Circuit Protectors CP30F Series

Notification regarding Changes in the Shape of the Accompanying Unit and the Type of the Separately Sold Accessory

Details of the Change in CP30F Accompanying Unit

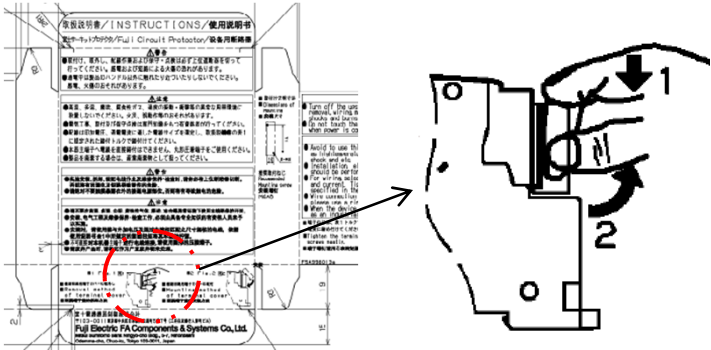
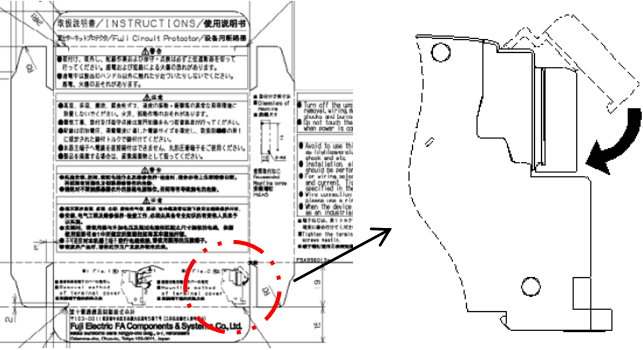
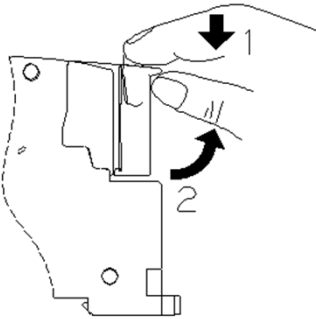
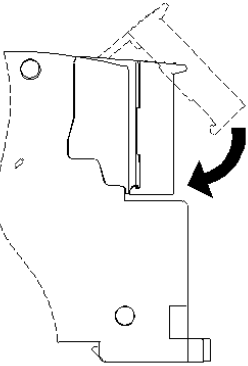
- (1) The accompanying terminal block structure is changed.
- (2) The accompanying terminal cover is changed.
- (3) With the shape change, part of the instructions is changed.

Before change	After change
(1) Accompanying terminal block		
Details of the change	<ul style="list-style-type: none"> - The upper surface has a flat surface continuously from the surfaces of the cover and case without steps. - The top/bottom pitch between terminals is expanded (only the top side is moved upward). 	
(2) Terminal cover		
Details of the change	<ul style="list-style-type: none"> - The upper surface has a flat surface continuously from the surface of the accompanying terminal block without a step. - The frontage of the wiring section is enlarged.
